RE: DA 2023/1529

WATERFRONT RETAINING WALL 55 ROBERTSON RD, SCOTLAND ISLAND, NSW

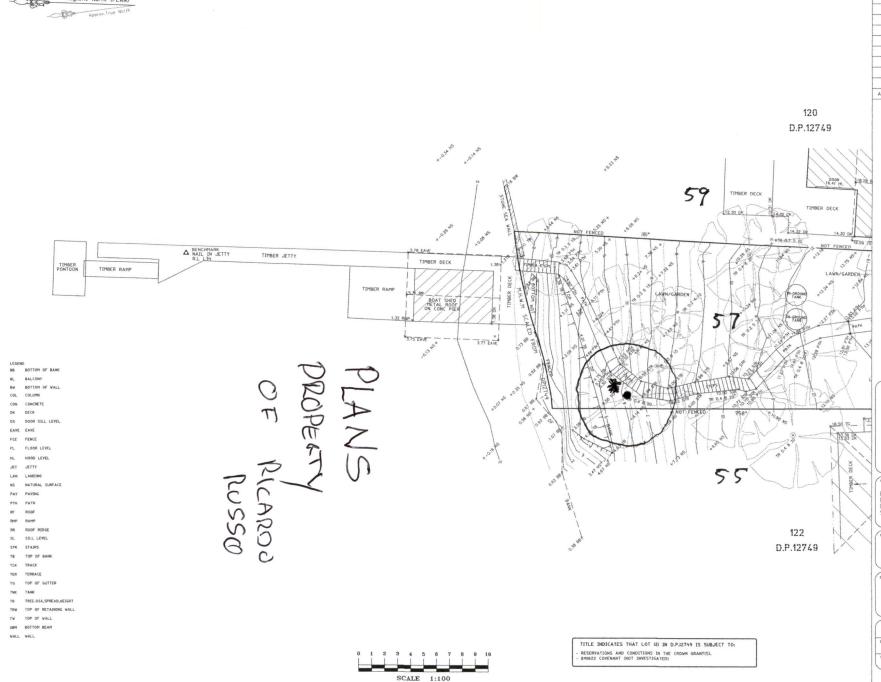
Impact on the adjacent spotted gum on No. 57 Robertson Road- It appears from the minimal drawings that the concrete retaining wall will come right to my boundary and the rear of the wall will be about 2m from a significant Spotted Gum on my foreshore land. The retaining wall will require excavation behind it, and onto my property, possibly up to 1m and this will eat into the critical root zone of this tree, see the attached survey plans 738detail and 738 pegout of my property showing this tree and the approximate position of the retaining wall, measured from the dimension back from the MHWM on the application plan.

No landscape plan- There is no Landscape Plan and no Arborist's report on the protected Spotted Gum, well within 5m of the excavation work.

Existing seawall and reinforcement forms part of the proposal and works extend about 1m beyond the MHWM onto Crown Lands, see my attached survey 738 pegout showing this part of the seawall, with no consent from Fisheries or Crown Lands.
